URGENT MEDICAL DEVICE CORRECTION

**Datascope Cardiosave Hybrid and Rescue Intra-Aortic Balloon Pumps (IABP)
Cybersecurity Vulnerabilities– Ripple20**

Figure 1 (back of Cardiosave Hybrid and Cardiosave Rescue unit)

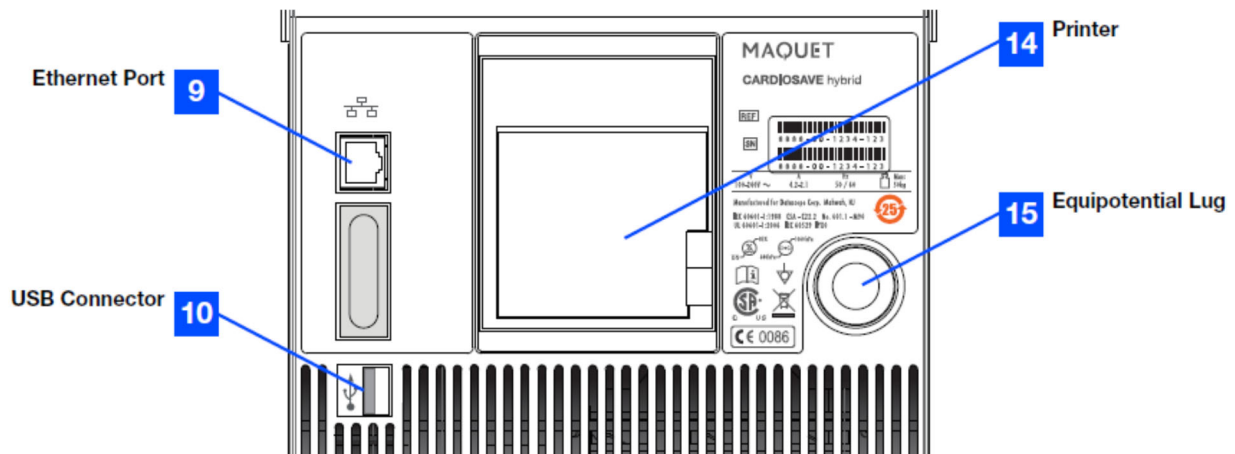
To ensure that Cardiosave Hybrid or Cardiosave Rescue are not susceptible to the Ripple20 vulnerabilities, users can disconnect the Ethernet cable from the Cardiosave Ethernet Port identified as item 9 in the image in Figure 1 below:

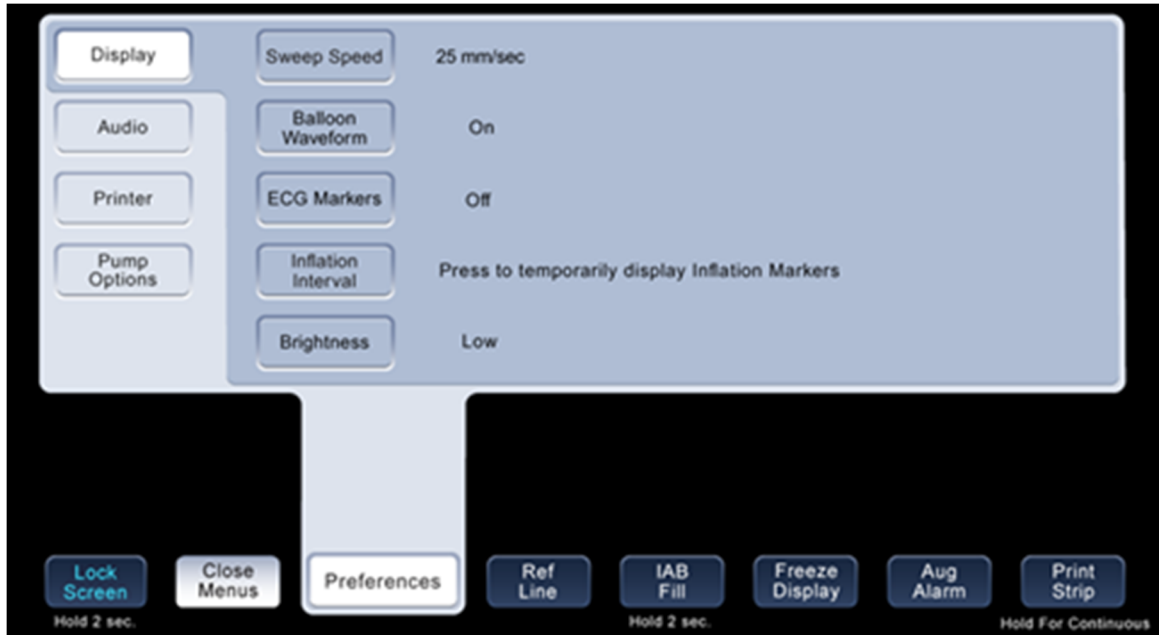
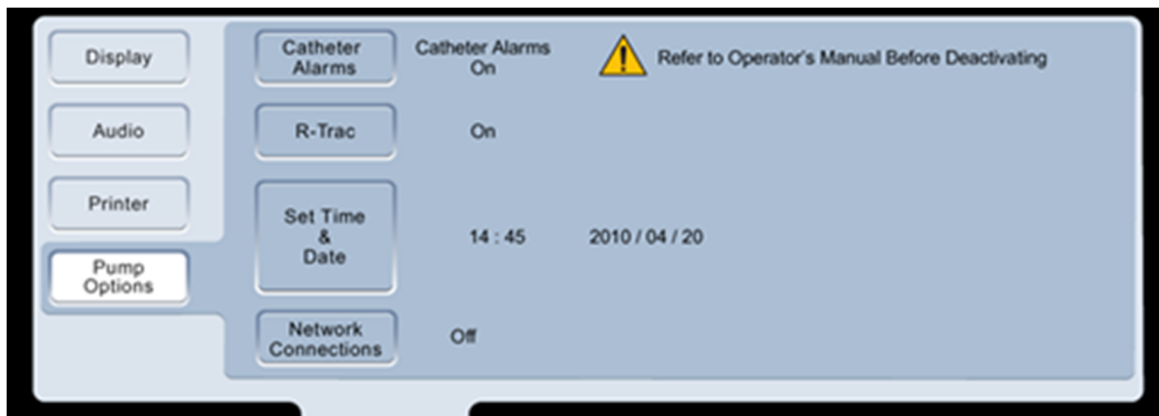
Additionally the user can turn off Network Connections via the **Network Connections** settings in the **Pump Options** menu. Ensure that the Connection Status indicator displays red after the Network Connections are set to Off.

To access the Network Settings Menus first press the **Preferences** key on the bottom row of the Keypad display to display the **Preferences Menu**.

Within the **Preferences Menu** select the **Pump Options** key to open the **Pump Options** sub-menu.

With the **Pump Options** Menu open select the **Network Connections** key to access the network options.

Select the **Off** key and confirm that the **Connection Status** indicator displays red.
